SERVICE BULLETIN

No. 300-1-01

Subject: Securing the wire stirrup of the gascolator bowl

EA-300	S/N 1 - 67
EA-300/L	S/N 1 - 133
EA-300/S	S/N 1 - 30
EA-300/200	S/N 1 - 29

Picture 1

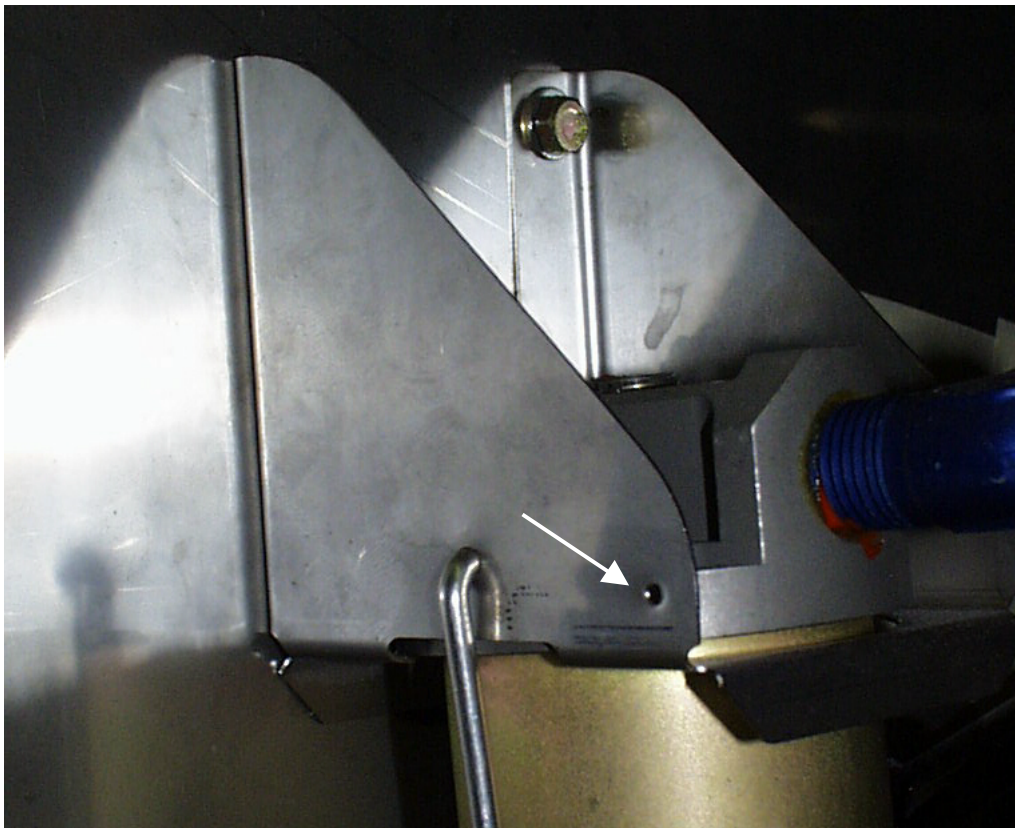
Purpose: Safety wiring prevents the wire stirrup from migrating outwards, causing the possibility of an unseated gascolator bowl.

- Drill a hole (3/32", 2mm) into the bracket (see picture 1).
- Safetywire the stirrup according the picture 2 below. Use safety wire dia. 0.032".
- Make appropriate entry of compliance with this service bulletin in the aircraft log.

The safety wire must be installed at the next scheduled inspection.
